Manual Supplement

Manual Title: 7526A Users
Print Date: July 2012
Revision/Date:

Supplement Issue: 2
Issue Date: 8/12
Page Count: 2

CD Title: 7526A
CD Rev. & Date: 8/2012
CD PN: 4181286

Change #2

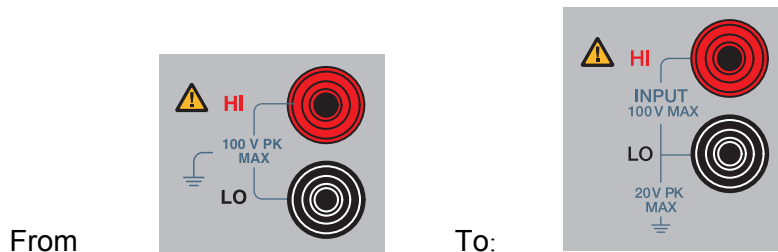
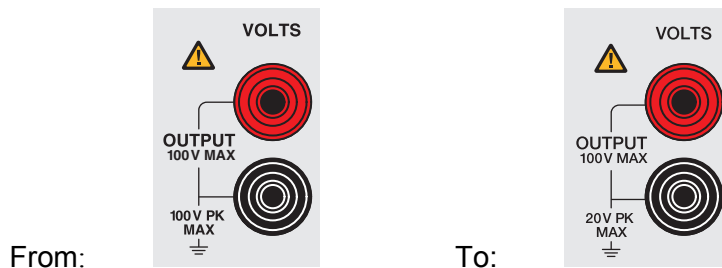
Throughout the manual, change all **Front Panel** figures:
